Estuary/Floodway Development Permit Request #851-24-000623-PLNG: Mauck Commercial Development & Boat Ramp

NOTICE OF ADMINISTRATIVE REVIEW Date of Notice: August 15, 2025

RE: Incomplete application for Floodplain Development Permit review 851-24-000623-PLNG

RE: Response to Incomplete application for Floodplain Development Permit review

Figure 3: Property Survey and Proposed Site Plan

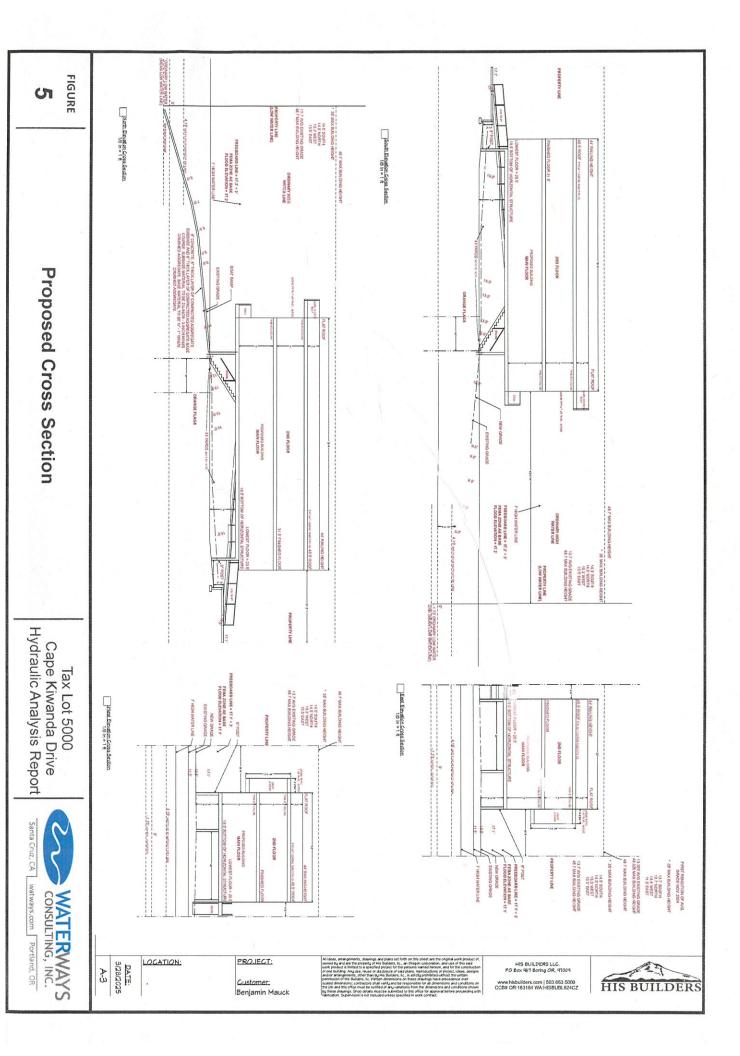
- Confirm net increase of fill on the site.
 - Plans show 43-cubic yards being graded across the property.
 - Does the fill volumes account for the added paved parking area, and the proposed boat ramp? As well as any fill for placement of a fence?

- Site plan:
 - Locations of existing trees/vegetation (indicate removal, if applicable), location and description of materials to be stored onsite during and/or after development, location and quantity of fill, grade and excavation activities, location of any restoration activities.

- See updated A-4 Plot plan for existing tree/vegetation locations, and A3 for grading activities.
 - A fence is detailed in the application description, but is not depicted on the site plan.

- The final grading plan now shows a net cut and removal of 230 cubic yards, taking into account the paved parking and boat ramp areas. See A-3 Cross Sections and A-4 Plot plan for details. No fences are used in the updated design.

- In 'Other' category, identify area for boat ramp.
 - Confirm if project includes any fill or dredging within estuary boundaries.
 - See updated A-4 Plot plan for boat ramp location and design. No fill or dredging to occur.

Figure 5: Proposed Cross Section

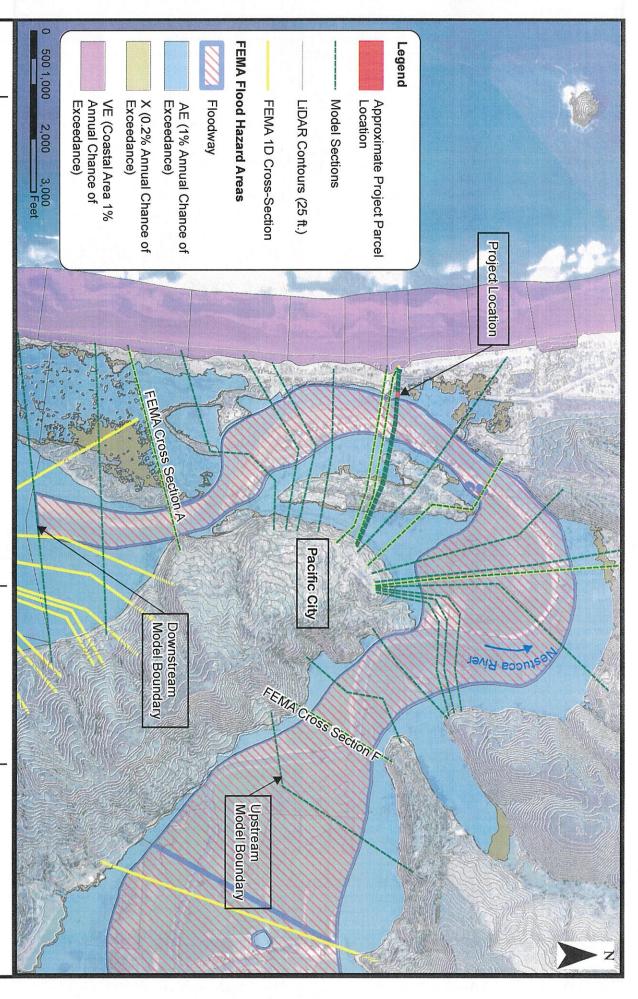
The proposed conditions model included the additional cross sections created in the existing conditions model. The existing condition terrain was updated based on the proposed grading sections presented on Sheet A-3 of the design drawings supplied by the client (**Figure 5**). Two 8-inch posts supporting the structure were included in the model as blocked obstructions. The proposed structure itself was not included as a blocked obstruction due to the structure being elevated above the FEMA BFE.
